Clarendon Ph3a Drawing Title Drainage Layout Sheet 1 of 3																			
<table border="1" style="width: 100%; border-collapse: collapse;"> <tr> <td style="padding: 5px;">DATE</td> <td style="padding: 5px;">Feb 20</td> </tr> <tr> <td style="padding: 5px;">DRAWN</td> <td style="padding: 5px;">SN</td> </tr> <tr> <td style="padding: 5px;">SCALE</td> <td style="padding: 5px;">1 : 100</td> </tr> <tr> <td style="padding: 5px;">DRG SIZE</td> <td style="padding: 5px;">A1</td> </tr> </table>	DATE	Feb 20	DRAWN	SN	SCALE	1 : 100	DRG SIZE	A1	<table border="1" style="width: 100%; border-collapse: collapse;"> <tr> <td style="padding: 5px;">CHECKED DO</td> <td style="padding: 5px;">JP</td> </tr> </table>	CHECKED DO	JP	<table border="1" style="width: 100%; border-collapse: collapse;"> <tr> <td style="padding: 5px;">CHECKED ENG</td> <td style="padding: 5px;">AH</td> </tr> </table>	CHECKED ENG	AH	<table border="1" style="width: 100%; border-collapse: collapse;"> <tr> <td style="padding: 5px;">PTA PROJ No</td> <td style="padding: 5px;">9669</td> </tr> <tr> <td style="padding: 5px;">REVISION</td> <td style="padding: 5px;">C19</td> </tr> </table>	PTA PROJ No	9669	REVISION	C19

DRAWING No W257-PTA-DE

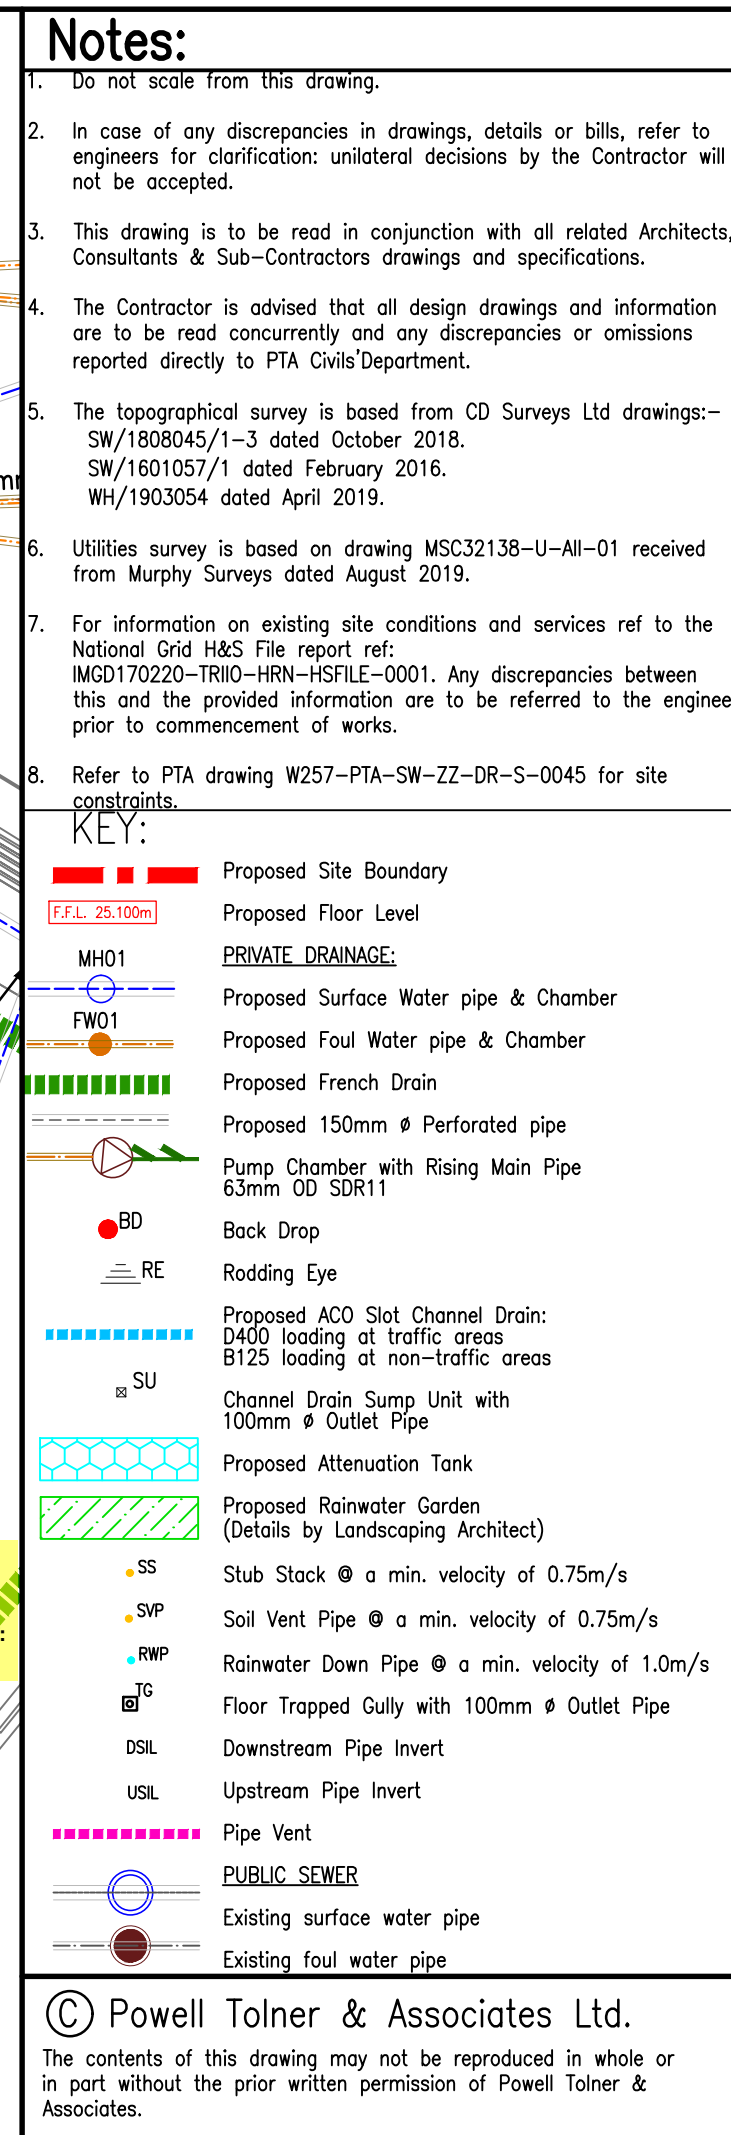
FOR CONSTRUCTION				
C11	floor gullies invert lvl added	SN	12.11.20	-
C10	D2 Terrace gullies added	SN	10.11.20	-
C9	Pumping Station chamber shape amended. Rising main & perforated pipe diameter added. channel drain amended	SN	30.10.20	-
C8	L&Q drainage added. Architect background amended	SN	15.10.20	-
C7	D1 L&Q drainage added	SN	08.10.20	-
C6	D1 & D2 Blocks SVP & SS amended to suit MEP layout.	SN	25.09.20	-
C5	Site Wide manhole covers level amended.	SN	14.08.20	-
C4	Drainage amended following a coordination exercise.	SN	06.08.20	-
C3	Drainage amended to suit Architect & M&E latest model	SN	16.07.20	-
C2	Drainage amended to suit M&E latest model	SN	22.05.20	AH
C1	Issue for Construction	SN	17.04.20	AH
P1	First Issue.	SN	13.03.20	
REV	DESCRIPTION	BY	DATE	CHK'D

C19	IC15 IL updated	JP	12.03.21	A
C18	FW15a/15/16 updated to as built positions FW17/18 levels updated	JP	02.03.21	A
C17	SW09 BD level ammended	JP	19.02.21	A
C16	Terrace drainage updated. Channel drain to D1 added.	JP	16.02.21	A
C15	FW15/ FW15a IL ammended. IC09b/IC09c shown in as-built position. CD added to terraces	JP	05.02.21	A
C14	IC09b & 09C moved & FW16 invert level ammended	SN	29.01.21	
C13	Perforated added	SN	06.01.21	
C12	RWP location & SW02 ammended	SN	25.11.20
